Burlington Development Review Board

Development Review Board

Tuesday, September 1, 2026, 5:00 PM

TO: Development Review Board
FROM: Scott Gustin
DATE: September 1, 2026
RE: ZP-24-50; 75 Briggs Street

PLANTING PLAN

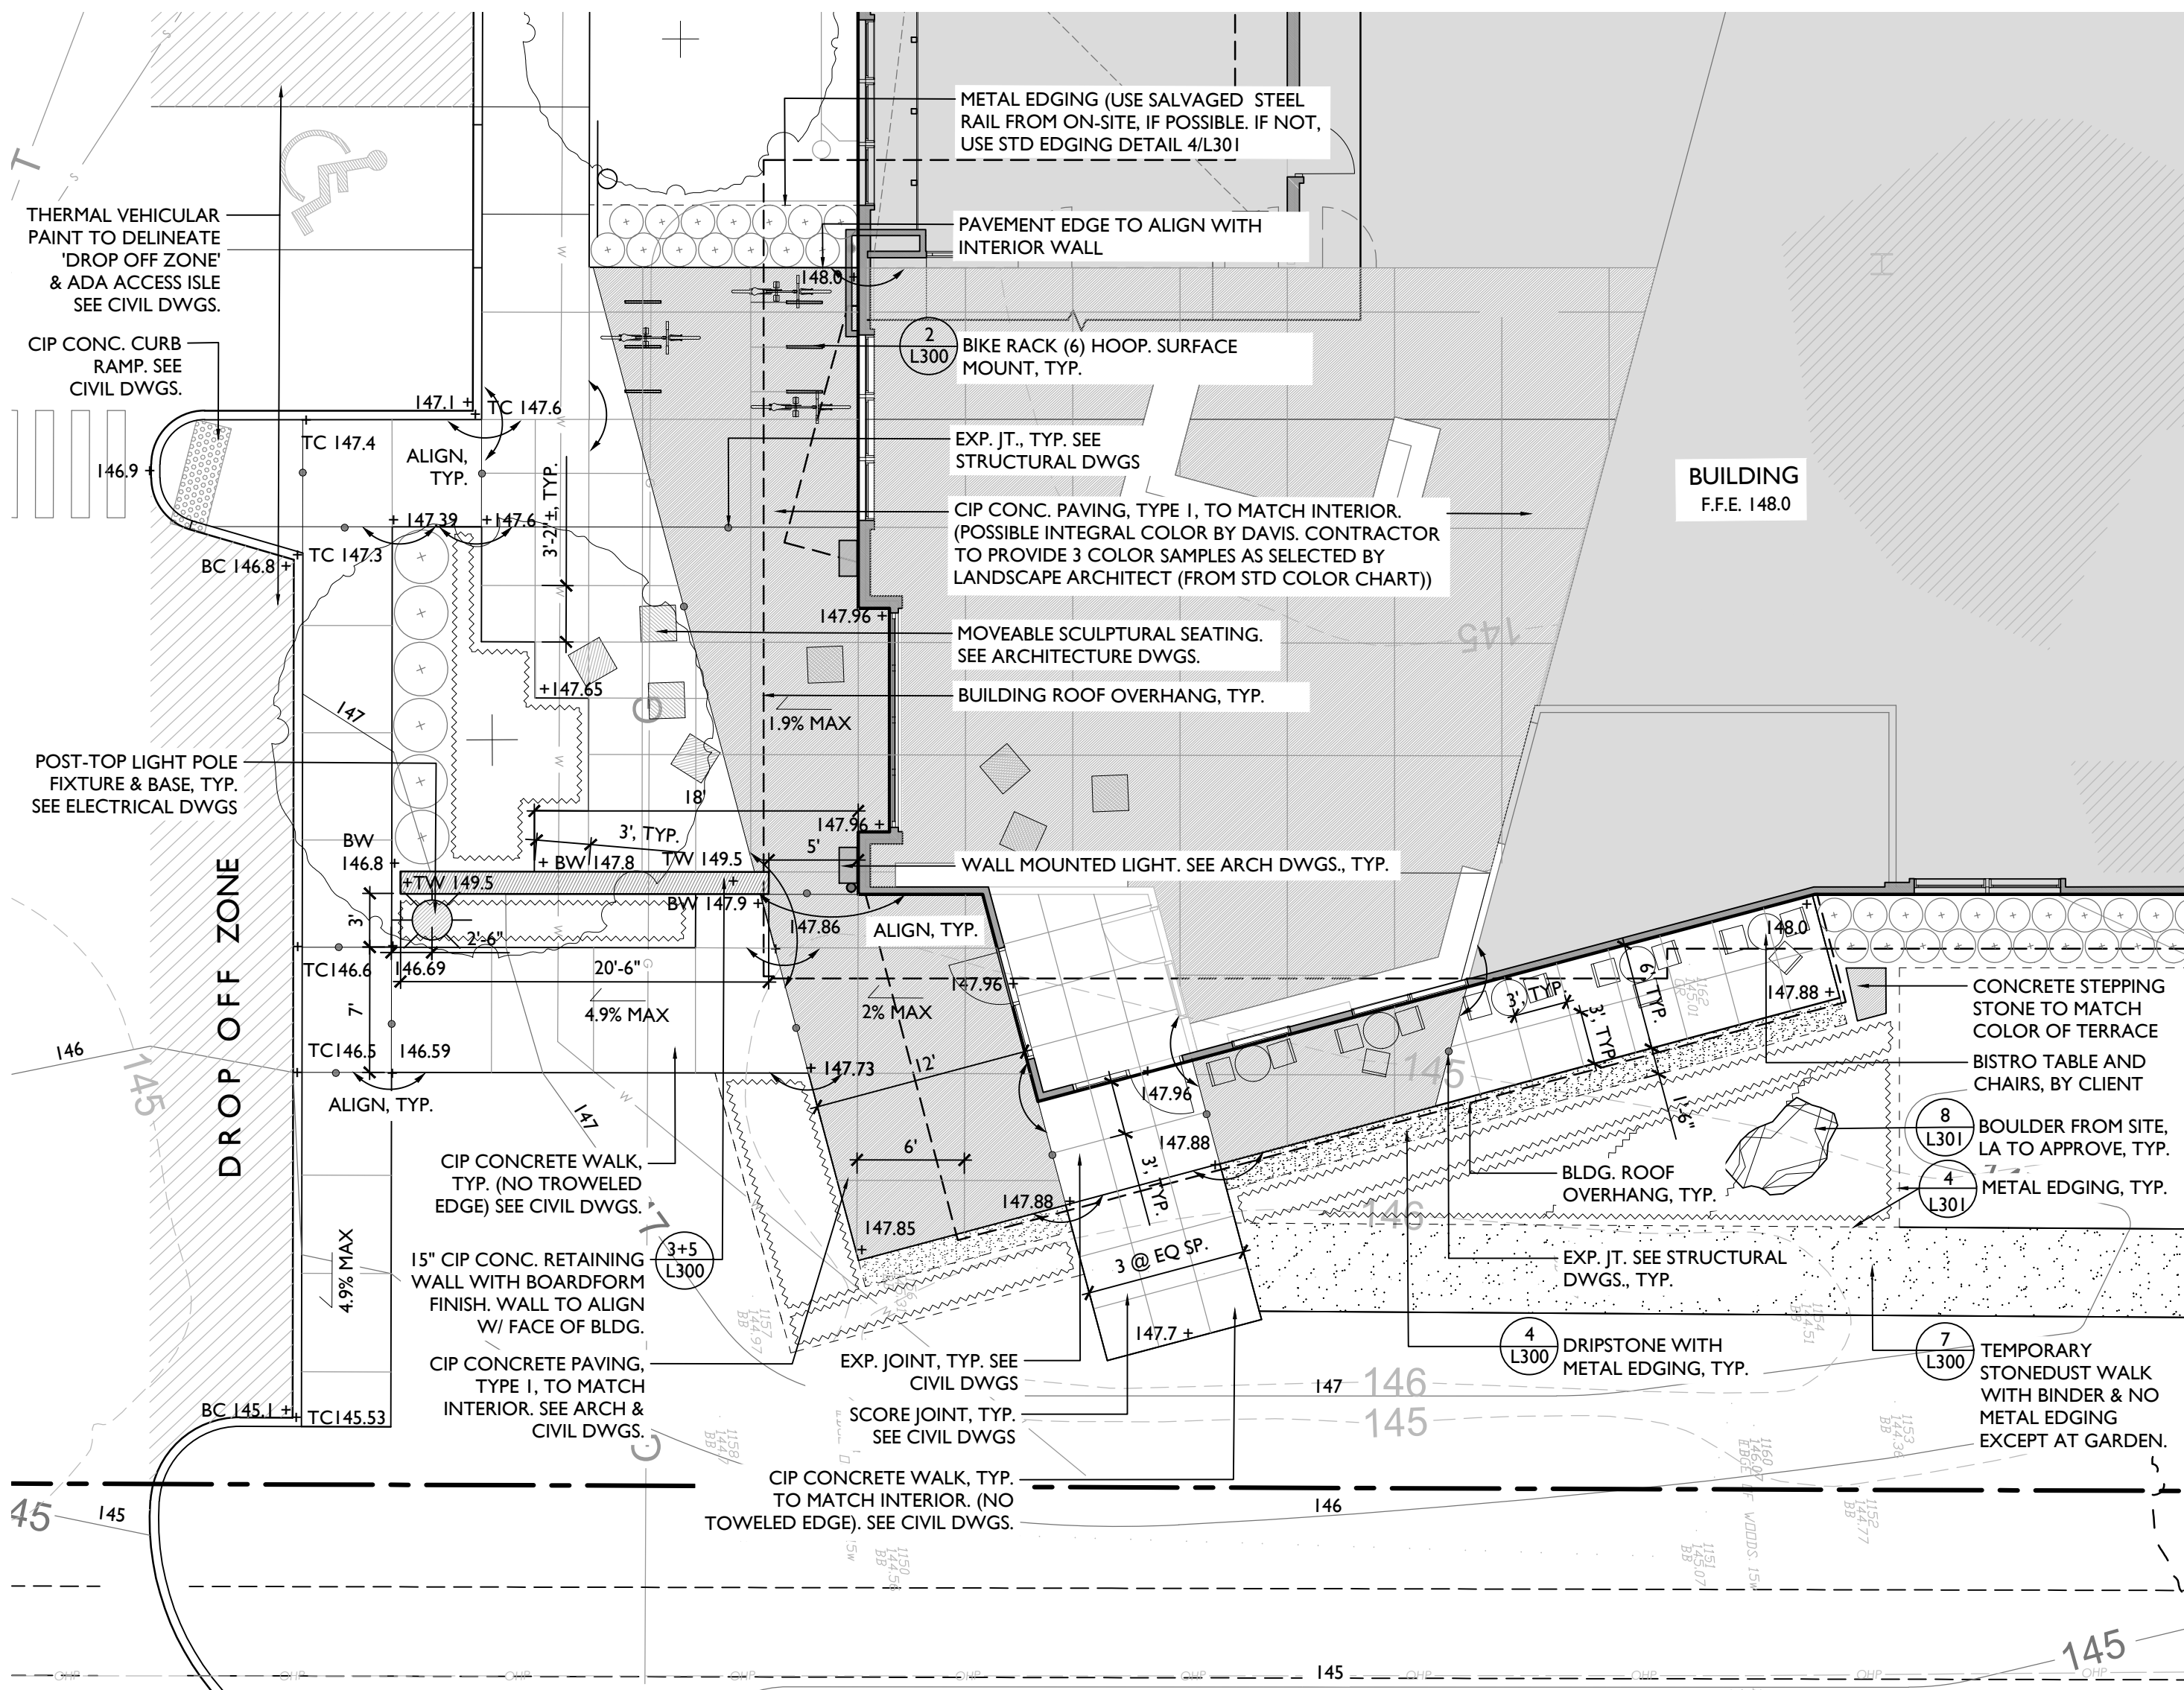
This criterion establishes a target of 30% shading of the parking area with new shade trees. At least 1 shade tree for every 5 parking spaces is required. The new parking lot contains 64 parking spaces and requires 13 shade trees. The shade tree planting plan and related shading analysis remain unchanged. As previously permitted, 45% shading of the parking lot is achieved.

The project plans include a landscaping plan that encompasses a variety of plantings. As noted above, shade trees will be planted in and around the parking lot. Additional plantings will accent the building and site features. As previously noted, screening of the parking between the two driveways is included in the project plans. **(Affirmative finding)**
